ITB # 201901 – Strothers Lane Tank

Questions & Answers

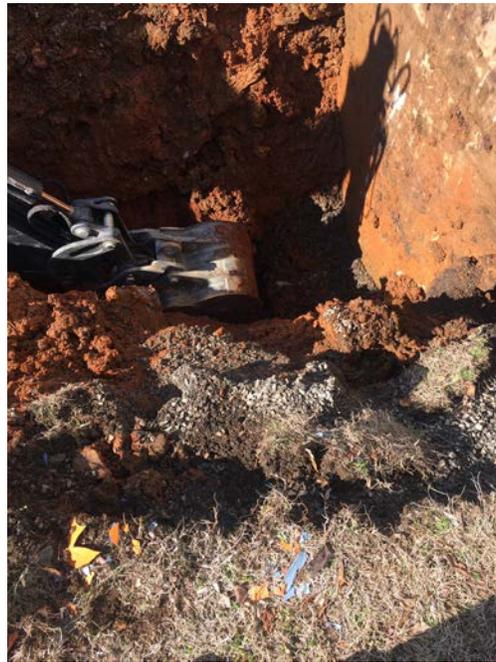
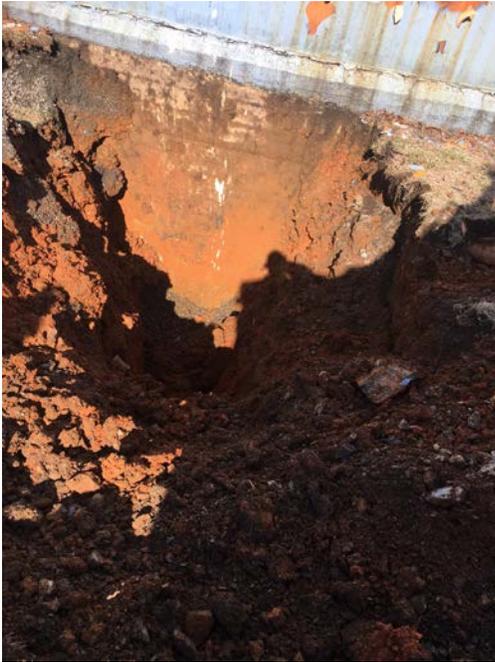
Q44. Is there any information regarding the thickness of the base slab the existing tank is on?
A44. It is not known if there is a base slab below the entire tank. There is a concrete ring wall around the entire circumference, which is approximately 36 inches wide and approximately 9 feet tall.

Q45. How deep is the tank?
A45. Test digging shows that there is an approximately 3' wide ring wall that is approximately 9 feet deep. Pictures taken during excavation are provided.
